[Docket No. FAA-2007-28688; Directorate Identifier 2005-SW-21-AD; Amendment 39-15312; AD 2007-26-10]

Airworthiness Directives; Bell Helicopter Textron Canada Model 430 Helicopters

SUMMARY: This amendment adopts a new airworthiness directive (AD) for Bell Helicopter Textron Canada (BHTC) Model 430 helicopters that requires replacing a certain servo actuator-to-actuator support attachment bolt (bolt) with an airworthy bolt. This action also requires establishing a retirement life for certain bolts and recording the retirement life on a component history card or equivalent record. This amendment is prompted by further evaluation of certain fatigue-critical parts, resulting in establishing a life limit of 5,000 hours for the affected bolts. The actions specified by this AD are intended to prevent fatigue failure of the bolt and subsequent loss of control of the helicopter.

Figure 1

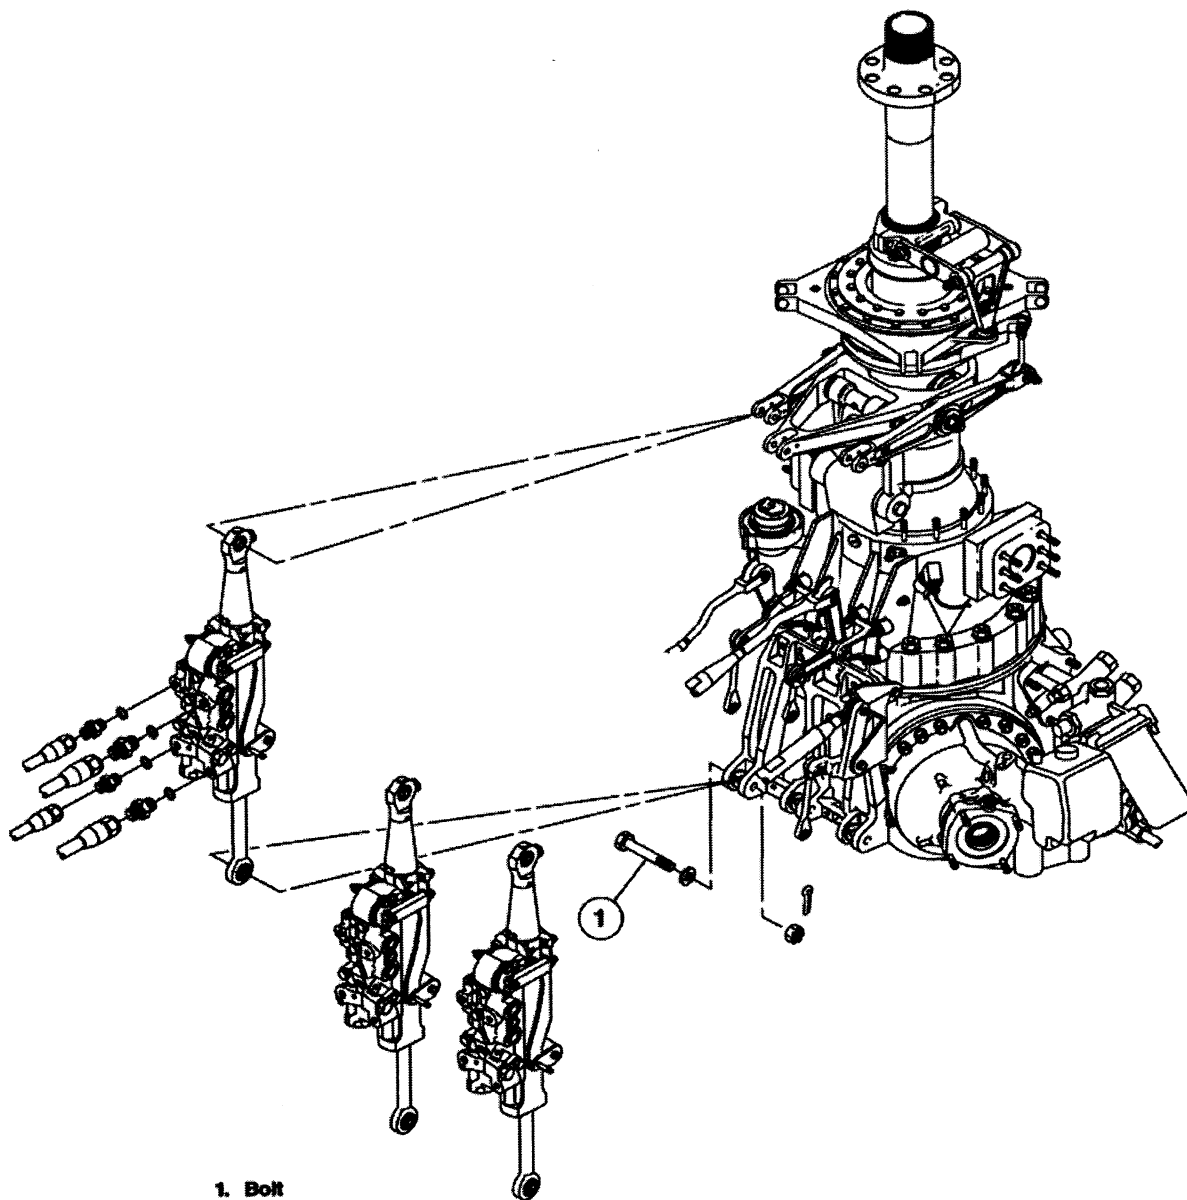
- (a) Within 150 hours time-in-service (TIS), replace all three affected bolts, as depicted for one of these bolts in Figure 1 of this AD, with airworthy, zero-time bolts, P/N 50-047C8-31.

Note 1: Only the right servo lower attach bolt (1) is shown. The collective and left cyclic servo lower attach bolts are also to be replaced. (This AD does not apply to the same part-numbered bolts at the upper end of each servo.)

(b) This AD revises the Airworthiness Limitations section of the maintenance manual by establishing a retirement life of 5000 hours TIS for each bolt.

(c) Record a 5000-hour TIS life limit for each bolt on the component history card or equivalent record.
